Bulletin No.: L03-005
Release Date: 02/24/03
Effective Date: Immediately
Supersedes: N/A
Completion Date: N/A

SERVICE BULLETIN

Ride Manufacturer: Larson International Inc. **Affected Production Dates:** All
Ride Name: Ring of Fire & Fire Ball **Affected Serial Nos.:** All units

Mandatory inspection requirements for actuator brass gear and actuator operating pressures. Some manuals refer to this assembly as “jactuator”.

STEP EIGHT

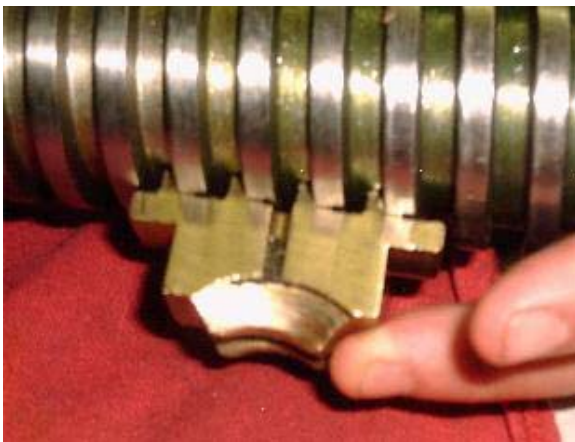
Remove bearing and actuator brass gear and inspect threads on gear. Degrease and inspect brass gear and bearing.

WARNING: Replace brass gear if threads are less than 3/16".

STEP NINE

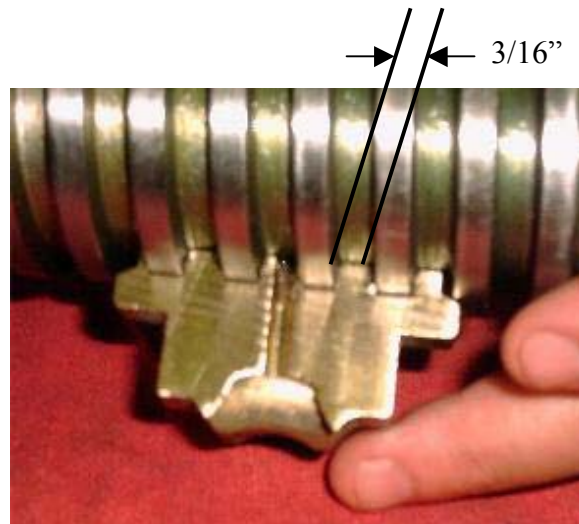
If brass gear threads are less than 3/16", install new brass gear. If threads are acceptable, reinstall.

UNACCEPTABLE

ACCEPTABLE
